RF/RMRS-97-023

**Soil Sampling and Analysis Plan  
to Characterize  
Individual Hazardous Substance Sites (IHSSs)  
121 and 148  
at Building 123**

***Review of Statistical Adequacy of Draft Soil Sampling and Analysis Plan to Support  
Building 123 D&D, 6-19-97***

SUBJECT: REVIEW OF STATISTICAL ADEQUACY OF DRAFT SOIL SAMPLING AND ANALYSIS PLAN TO SUPPORT BUILDING 123 D&D - TRG-015-97

Figure 4.1 Soil Sampling Locations

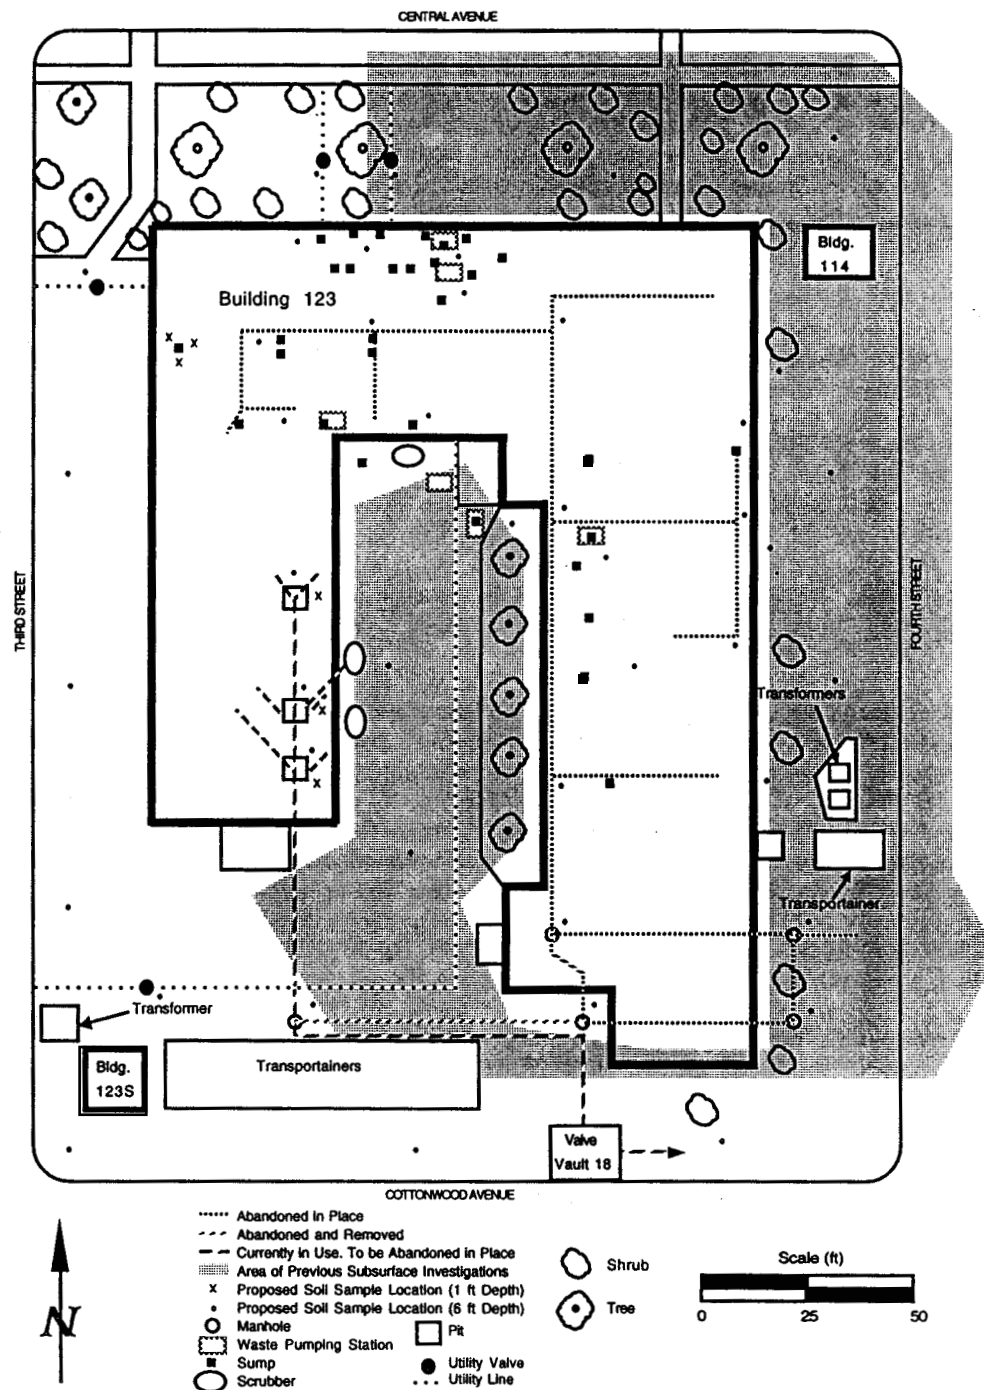
With respect to the potential existence of hot spots, likely locations would be in the vicinity of sumps and points of redirection of underground process waste lines (PWL). The existence of hot spots elsewhere is unlikely based upon the historical information and the results of earlier characterization efforts for IHSS 148. The probability of detection of a hot spot is a function of its expected planar size and shape and the likelihood that a sample location falls within the hot spot footprint. (R. O. Gilbert, 1987, *Statistical Methods for Environmental Pollution Monitoring*, Van Nostrand Reinhold, provides more detailed discussion on this subject.) Since all of the likely hot spot locations are beneath the building slab and unlikely to be affected by leaching by rainwater, a generally circular diffusion pattern and downward infiltration path can be assumed.

Based upon the locations shown in Figure 4.1 of the proposed sampling plan and assuming they are plotted to scale, it is estimated that any hot spot with a radius of fifteen feet or greater would be detected with approximately ninety-five percent probability. Any hot spot emanating from a sump with a radius of twelve-feet or more or emanating from a PWL point of redirection with a radius of six feet or more would be detected with approximately eighty percent probability. If hot spots of smaller size are anticipated, high detection probabilities can only be achieved by increasing the number of samples and fixing their locations closer to the more isolated potential hot spots.
